Quality Audit – Stage 1

Shanganagh Castle Residential Neighbourhood

On behalf of Dún Laoghaire-Rathdown County Council

4.2.15 Footpath Dead-ends

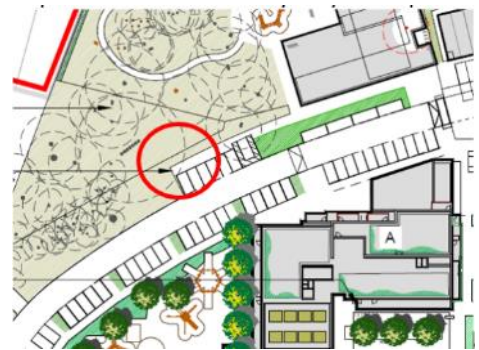
Problem: Pedestrians may encounter dead ends to footpaths. This is of particular concern to sight impaired users where they may attempt to continue their journey across the unpaved surface.

Recommendation: Ensure all footpaths provide a continuous route, even if this requires a road crossing or provide hazard tactile.

4.2.14	Y	Y	Item accommodated in revised drawings	
4.2.15	Y	Y		
4.2.16	Y	Y		
4.2.17	Y	Y	Different surface finishes and floor signage to be provided.	
4.2.18	Y	Y

4.2.16 Areas of Raised Carriageway

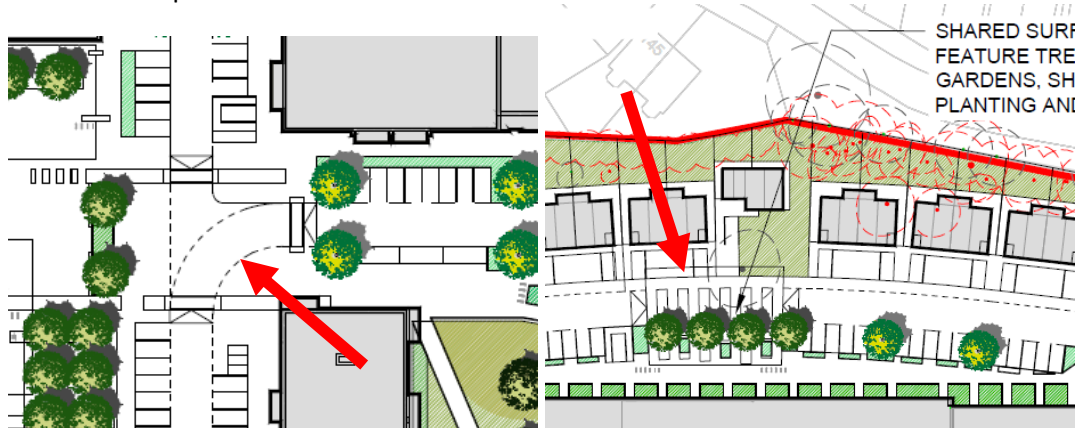
Problem: There are several areas of carriageway shown as 'raised' with a dotted line at the carriageway edge. It is not clear how the footway is to be segregated from the carriageway in these areas. Sight impaired users may experience difficulty in traversing these areas and finding their intended footpath continuation.

Recommendation: A clear identifiable route should be provided for sight impaired users through the entire development.

4.2.17 Shared Cycle / Pedestrian areas

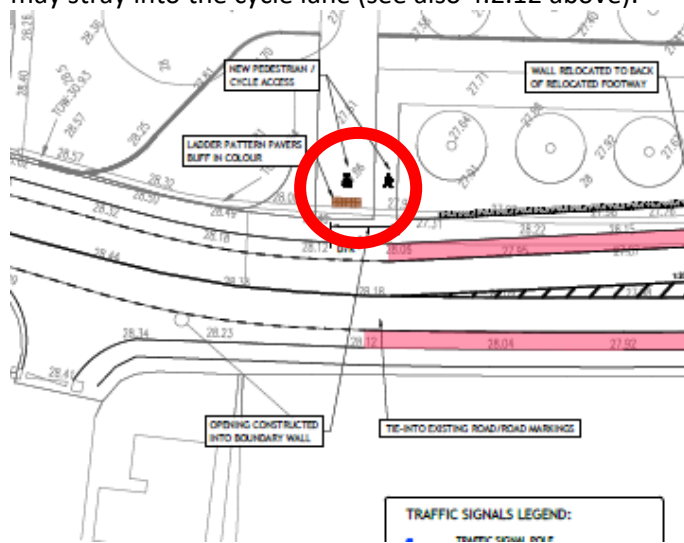
Problem: No segregation is shown between the cyclist and pedestrian user. Sight impaired users may stray into the cycle lane (see also 4.2.12 above).

Recommendation: Segregate pedestrians from cyclists.

Figure 4.4.1

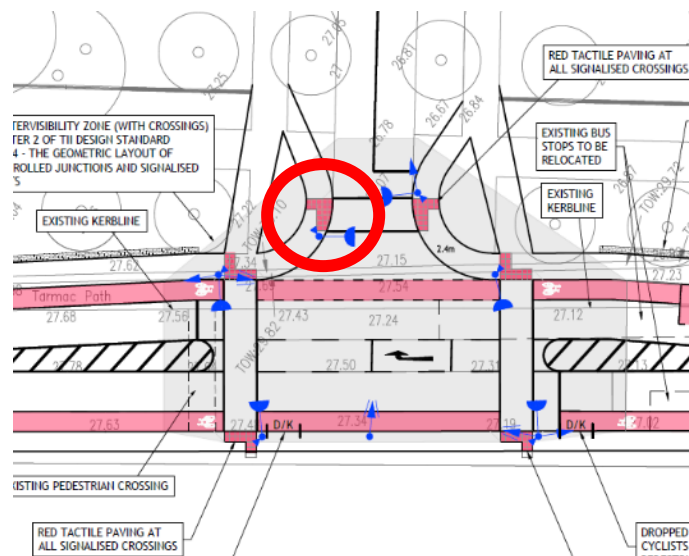
Ref	Feature	Conforms	Access Comment	Action
4.4.1	Is the crossing type appropriate for the location?	Yes		None required
4.4.2	Does the controlled crossing have tactile paving in compliance with the standards and red in colour	No	Tactile 'L' shown incorrectly, See Fig 4.4.1 below	Design Team update layout

4.3.3	Y	Y		
4.4.1	n/a	n/a		
4.4.2	Y	Y		
4.4.3	Y	Y	All trees previously proposed within the sightlines have been removed however there remains 1 incident where an existing tree is being retained within the sightline. Proposed crown lifting to be done to improve condition.

Figure 6.1.4 – No direct pedestrian route

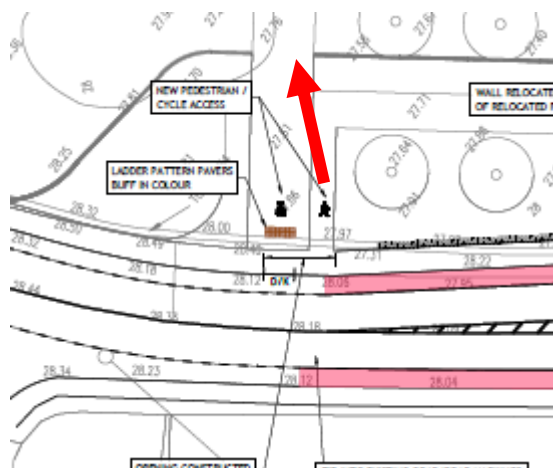
6.1.3	Do the footpaths terminate at an appropriate location?	Yes		N/A
6.1.4	Are the footpaths direct without unnecessary diversions, loops etc?	No	Northern access promotes pedestrians to make use of the cycleway (see Fig 6.1.4)	Redesign the footway to provide access to the northern areas of the development.

6.1.3	n/a	n/a		
6.1.4	Y	Y	This is a shared pedestrian and cycle entrance. Signage to be provided. Different surface materials currently provided.
